Fast Prototyping Board for RA2E1 Microcontroller
Group
FPB-RA2E1 v1
Errata

Renesas RA Family
RA2 Series

This Errata describes the known issues and exceptions to the functional specifications for the FPB-RA2E1 v1, Fast Prototyping Board for the RA2E1 MCU Group. For additional information on the kit, see the FPB-RA2E1 v1 user's manual.

Figure 1. MCU Pin Header J3 Pin 32 Silkscreen Error

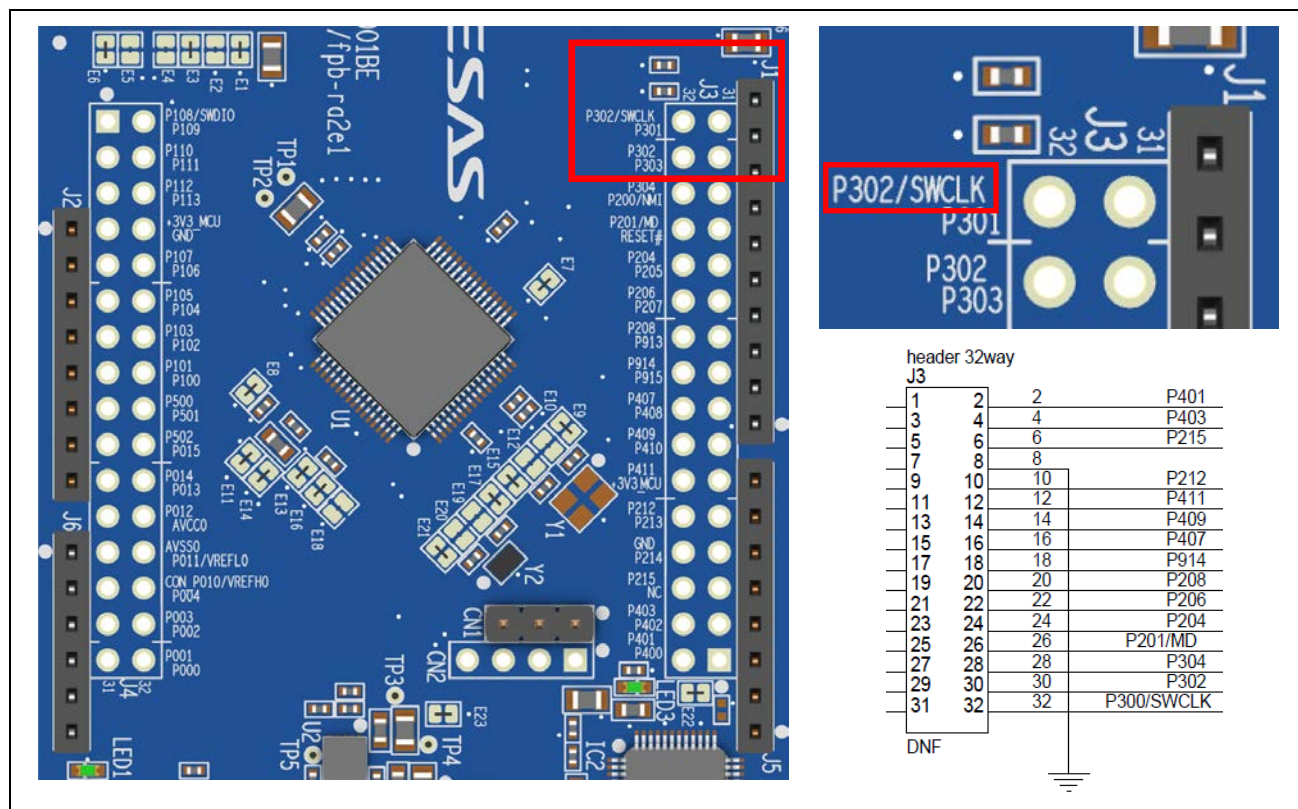
The MCU Pin Header J3 has an incorrect label for pin 32. This is identified as P302/SWCLK when it should be P300/SWCLK. The schematic is correct.

None. The silkscreen has been corrected to show the correct pin identification on later builds of the board.

Figure 2. E27 and CN3 on FPB-RA2E1

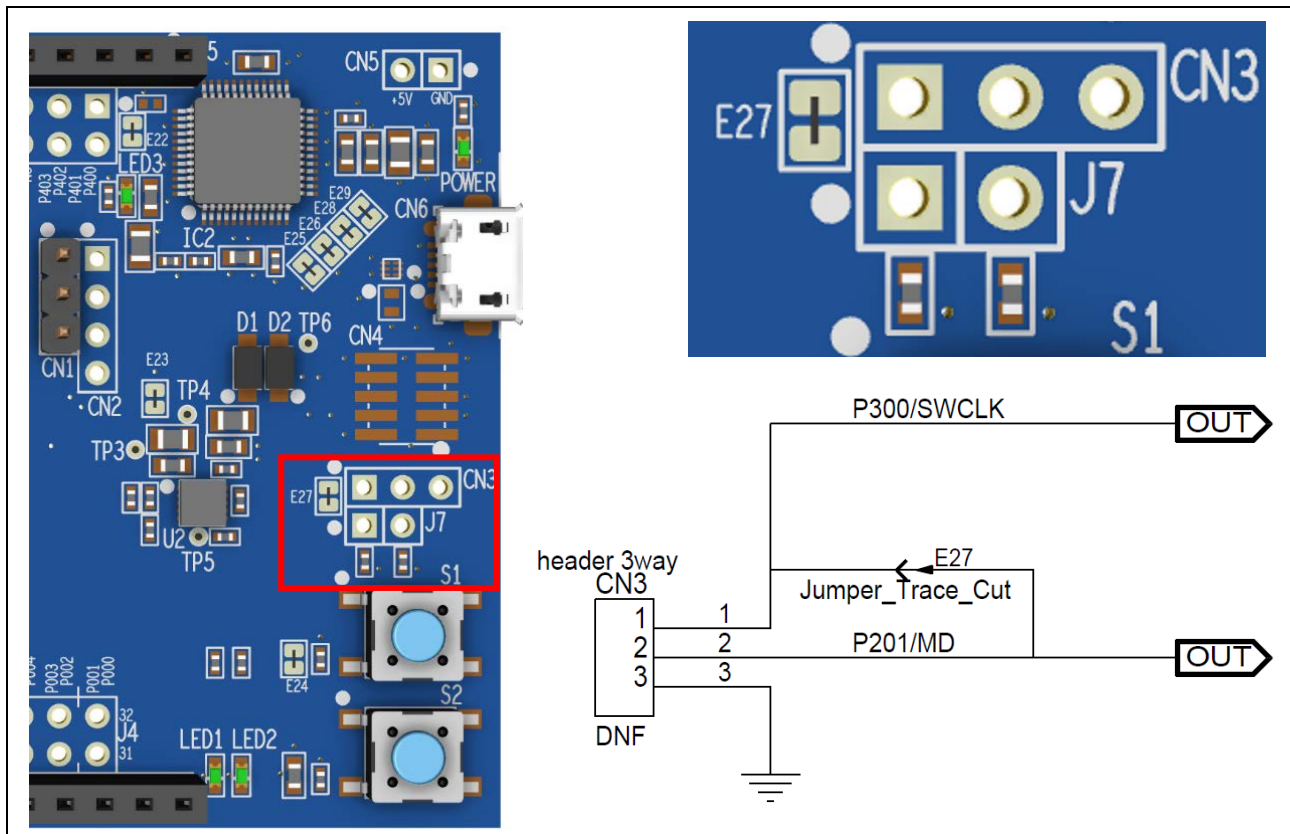
Error 0x00030108: Rewriting of the MCU's internal flash ROM was not normally executed due to access violation to the MCU's internal flash ROM.

This has been identified as a hardware issue. To fix this error, cut trace-cut jumper E27, disconnecting P300/SWCLK from P201/MD. **This will disable the SCI boot selection option.** To re-enable SCI boot selection, pins 1-2 of CN3 must be connected. Jumper CN3 is not fitted to the FPB-RA2E1, [Wuerth Elektronik MPN: 613 003 111 21](#) is recommended to fit if required.

Further developments include improving the emulator firmware to allow P300/SWCLK and P201/MD to be connected without receiving the error message.
